Industry/TSTF Standard Technical Specification Change Traveler

Revise LCO 3.5.5 for RCP seal injection flow resistance

NUREGs Affected: ☐ 1430 ☒ 1431 ☐ 1432 ☐ 1433 ☐ 1434

Figure 3.5.5-1 (page 1 of 1)
Seal Injection Flow Limits

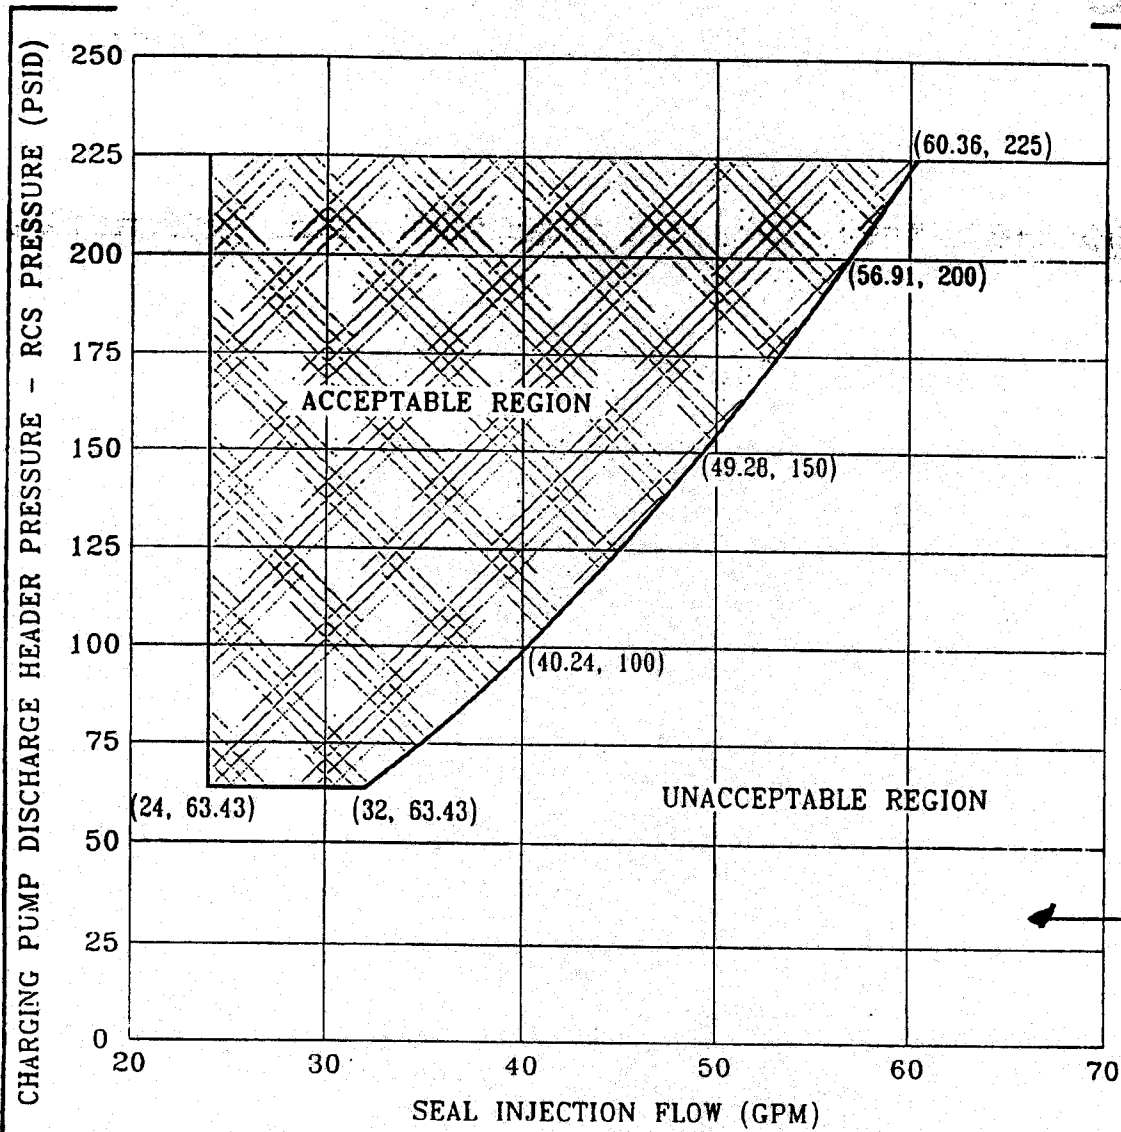
Change Description: Added Figure 3.5.5-1

The LCO is not strictly a flow limit, but rather a flow limit based on a flow line resistance. In order to establish the proper flow line resistance, a pressure and flow must be known. The flow line resistance is established by adjusting the RCP seal injection flow in the acceptable region of Figure 3.5.5-1 at a given pressure differential between the charging header and the RCS. The centrifugal charging pump discharge header pressure remains essentially constant through all the applicable MODES of this LCO. A reduction in RCS pressure would result in more flow being diverted to the RCP seal injection line than at normal operating pressure. The valve settings established at the prescribed centrifugal charging pump discharge header pressure result in a conservative valve position should RCS pressure decrease. The flow limits established by Figure 3.5.5-1 ensures that the minimum ECCS flow assumed in the safety analyses is maintained.

Reactor coolant pump seal injection flow shall be $\leq [40]$ gpm with
 [centrifugal charging pump discharge header] pressure $\geq [2480]$ psig and
 the [charging flow] control valve full open, or $\geq [0.2117]$ ft/gm² or
 within the limit of Figure 3.5.5-1.

or \geq [0.2117] ft/gpm² or within the limit of Figure 3.5.5-1.]
